Lead Local Flood Authority

RE: DISC/26/0085 - Land At 509354 126590 Hilland Road Billingshurst West Sussex RH14 9HN

This is an application for Approval of details reserved by condition 5 to approved application DC/25/0458 (surface water drainage).

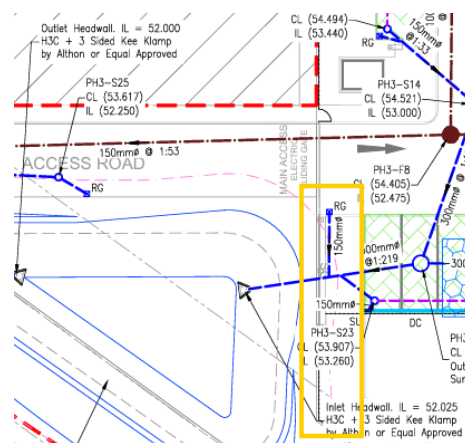
2. We require a drawing with the connectivity and capacity of the surface water network from proposed outfall to open watercourse.
This has been addressed
3. Calculations for surcharged outfall.
This has been addressed
4. Construction drawings of surface water drainage network, sustainable drainage components and flow controls (including cross sections).
The provided drawings are labelled 'preliminary' (not for construction). At discharge of conditions stage we require 'for construction' drawings to be provided, please update accordingly
5. Construction method statement – while we note the comment in para 1.6, this is not adequate information for a discharge of condition application.
This has been adequately addressed
6. Maintenance easements must be clearly shown on drawings.

Please can the Applicant confirm if the land to the west of the red line boundary is under their control? It is noted that the boundary curtails the maintenance buffers for the basins. There is also a constriction at the below point in yellow (which will be less of a concern if access is available to the rest of the basin, as above):
